⚠ CHANGE ORDER NO. 1 5-02-05

LATERAL 1, MAIN 6 OF THE NORTHWEST INTERCEPTOR SEWER

SANITARY SEWER LINE NO. 1

JAMES L. ARMOUR, P.E. – ACTING CITY ENGINEER
CITY OF WICHITA PROJECT NO. 468-83969

SANITARY SEWER LINE NO. 1

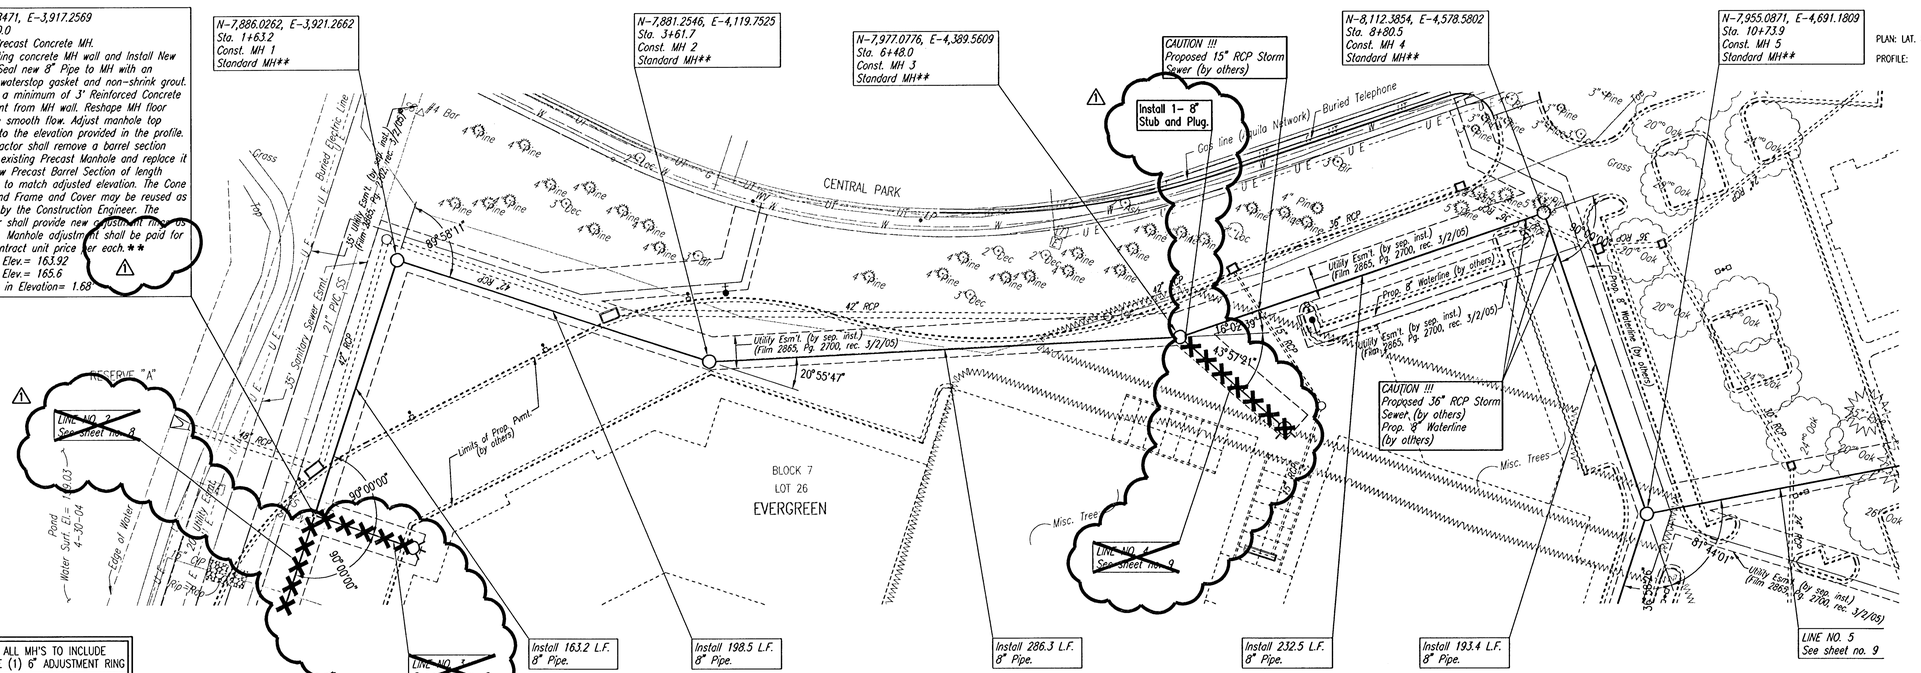
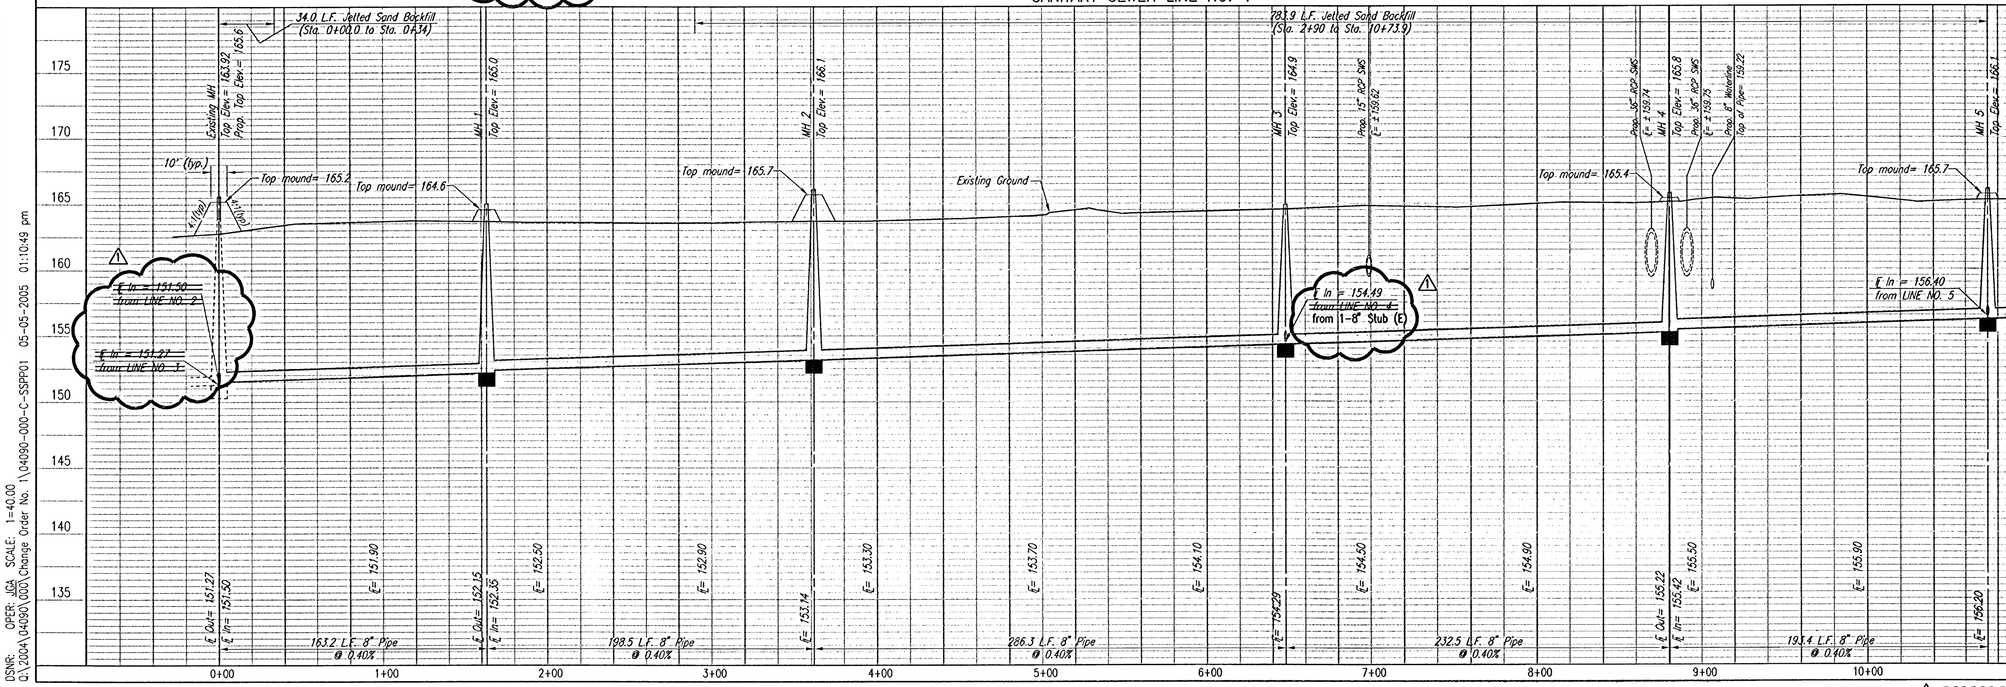
N-7,722.8471, E-3,917.2569
Sta. 0+00.0
Existing Precast Concrete MH.
Core existing concrete MH wall and Install New 8" Pipe. Seal new 8" Pipe to MH with an approved waterstop gasket and non-shrink grout. Construct a minimum of 3' Reinforced Concrete Encasement from MH wall. Reshape MH floor to provide smooth flow. Adjust manhole top elevation to the elevation provided in the profile. The Contractor shall remove a barrel section from the existing Precast Manhole and replace it with a new Precast Barrel Section of length necessary to match adjusted elevation. The Cone Section and Frame and Cover may be reused as approved by the Construction Engineer. The Contractor shall provide new adjustment rings as necessary. Manhole adjustment shall be paid for at the contract unit price per each.**
Exist. MH Elev.= 163.92
Prop. MH Elev.= 165.6
Difference in Elevation= 1.68
